DATE:	February 20, 2013	CO #:	03 (Three)
TO:	Endeavor Construction Company 977 State Route 28 Milford, Ohio 45150	PROJECT:	Gallatin County Alternative School & Field House Gallatin County, Kentucky BG 12-133 RTA 0914
CONTRACT DATE:	December 5, 2012	CONTRACT FOR:	General Construction

DESCRIPTION: **Soil Condition Proposals at the Plan-South Alternative School & Field House Building Pad Area** (a follow up to the response to RFI#004).

Re: Subgrade and Geothermal Well Observation
Gallatin County Alternative School & Field House
Warsaw, Kentucky

Project: Gallatin County Alternative School
Architect: Ross Tarrant Architects
RFI No: 004
Date: 01/25/13
Subject: Soil Condition for Alternative Building

Subject Subgrade

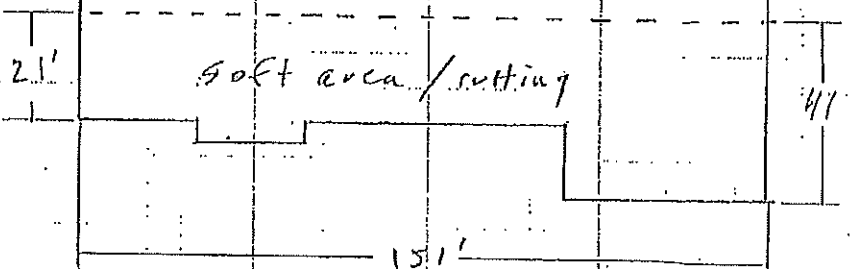
- a) Cut 12 inches down where soft soils exist under the Alternative Building pad,
- b) Replace removed soils with DGA and,
- c) Provide pricing bringing up to sub-grade with DGA in lieu of soils.

S&ME observed the building pad subgrade. Based on discussion with Mr. Jones, it is understood the north section of the building pad was previously a parking area and stability in the area is not a concern. The south area of the building pad, as shown on the attached sketch, was previously proofrolled and ruts were observed to depths of 6 to 8 inches. Hand augering was performed at several locations. Weak clayey silt soils were encountered to a depth of approximately 12 inches. The soils observed would typically become unstable when exposed to excess moisture.

S&ME recommends the soft soils be cut to a depth of 12 inches below subgrade. The soils should be replaced with crushed stone base (Kentucky Department of Highways Standard Specification Item 805.15 or similar crushed stone material).

The portion of the building pad area on the south side that did not meet proof-roll should be undercut 12" and brought to subgrade elevation with crushed stone per the Geotechnical Engineer's observation and recommendation letter dated February 12, 2013.

Based on deminsions provided on sketch. $21 \times 41 \times 151$. $21' + 41' = 62'$ divided by 2 = 31' average.
